Ref; Planning Application BE/60/15/PL

To be discussed at the Development Control Committee **Meeting 23rd September** 2015

TITLE NUMBER	
WSX101976

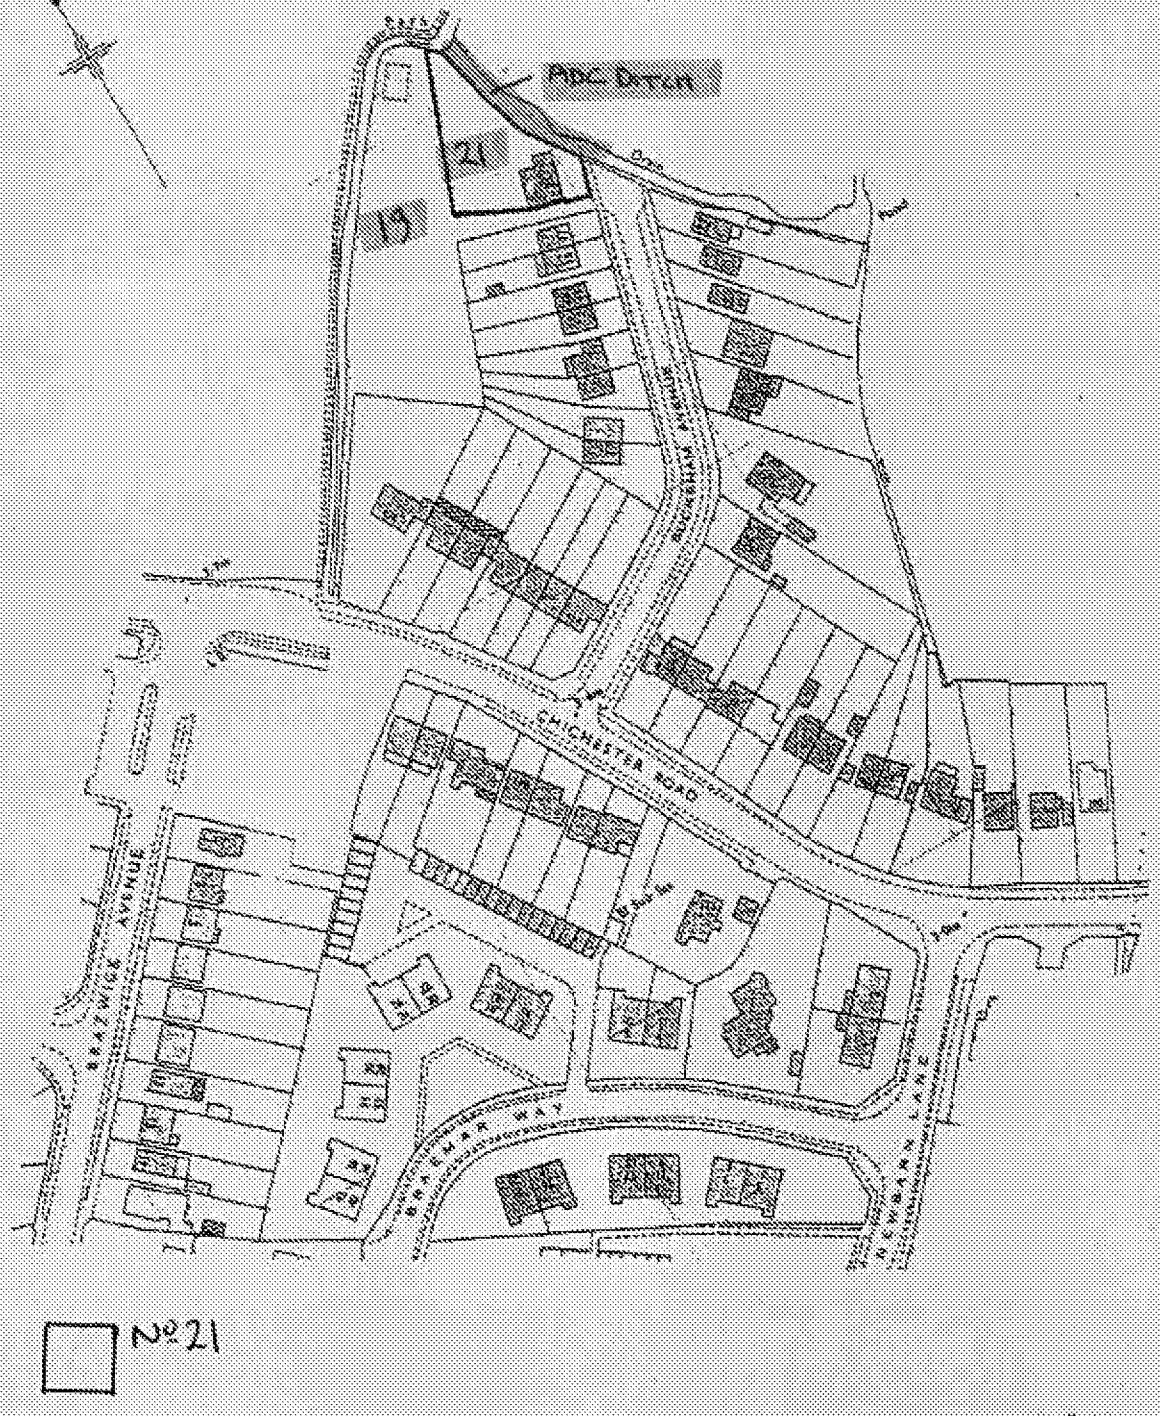
I have enclosed a copy of the land registry plan for 21 and the latest revised block plan. Plainly the application is intentionally **mis-leading** and the proposers continue to attempt to use ADC land for their own purposes – land which is flood zone 3b and previously refused for development by ADC under BE/157/11 as a water course.

BLOCK PLAN
(1:500)
TURNING RADIUS LESS THAN 4METRES
ADC DITCH
P1
P2
P3
P4
P5
P6
P7
P8
21
N
VIVID
design studio
Proposed Residential Development
West Sussex
Block Plan
120096
C

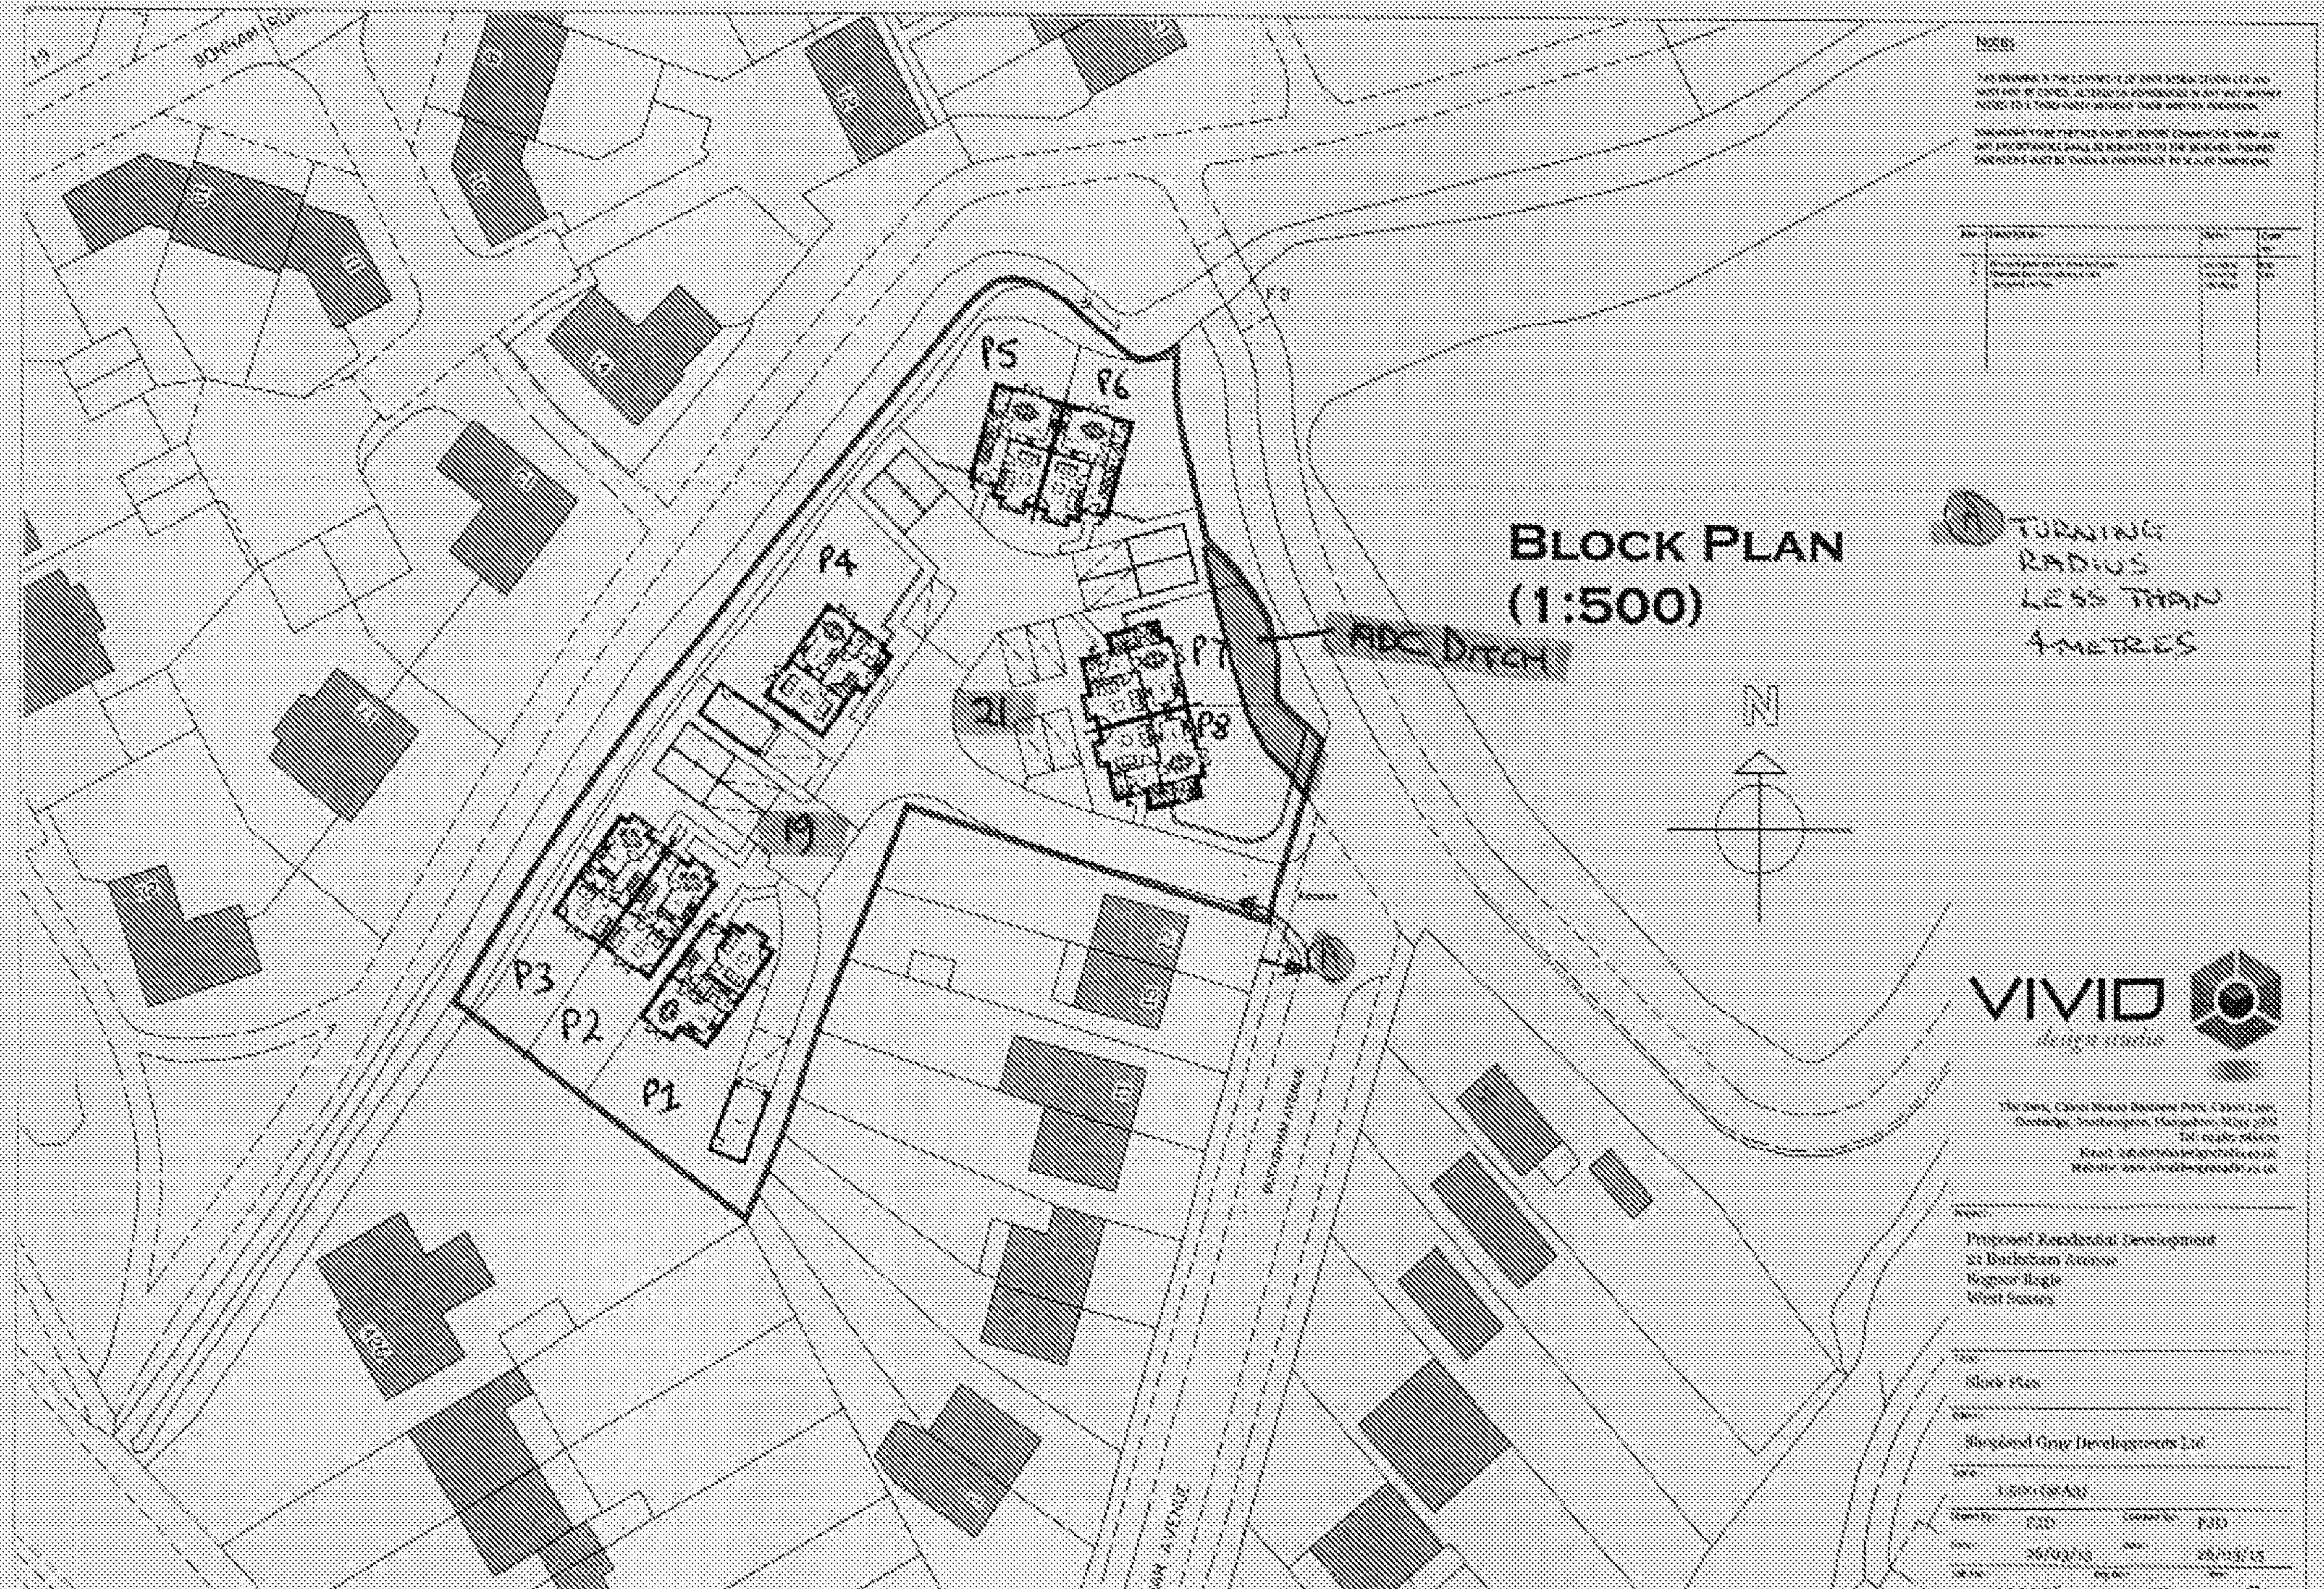
Where, as in this case, this is unachievable the proposals must conform to paragraph 11.2 where vehicle access must be within 45 metres of all points of a dwelling house. In this case this in the first floor south west corner of plot 3. In actual fact this is in excess of 50 metres direct travel distance from outside the existing 17 and more than 55 metres in actual travel distance. Therefore the access is wholly inadequate.

With the significantly revised block plan the proposals contain a number of further inadequacies with regard to **policy GEN 7;-**

- There is inadequate visitor parking, the previous 3 spaces have been reduced to 1 for 8 houses. (This contradicts the minimum parking requirement at the original pre-planning consultations and meetings of 2014/15).

- There continues to be no pedestrian path into the site which, with plots 7 & 8 now discharging cars directly onto the access road significantly increases the danger to both pedestrians and vehicles. This has previously been objected to by Bersted Parish Council in the original layout. (This contradicts the safety considerations given to this access road at the original pre-planning consultations/meetings of 2014/15).

- There is unacceptable noise and disturbance to 15 & 17 by the changed vehicle parking and manoeuvering to plots 7& 8.
- The first floor windows comprising bedroom 3, landing and bathroom of plot 8 over look existing numbers 15 and 17. These properties are occupied by the vulnerable elderly and young families. The windows are unneighbourly, directly compromise the privacy of these residents and would form an unsatisfactory backland development which would harm the privacy and quiet enjoyment of these neighbouring properties.

- Unless the applicants can use the part of the ADC drainage ditch adjacent to plots 7 & 8 then the garden for those plots provides insufficient garden space and private amenity for any occupants of those plots. Additionally the ditch forms part of flood zone 3b which, according to NPPF guidance, prohibits any form of domestic dwelling on that land.
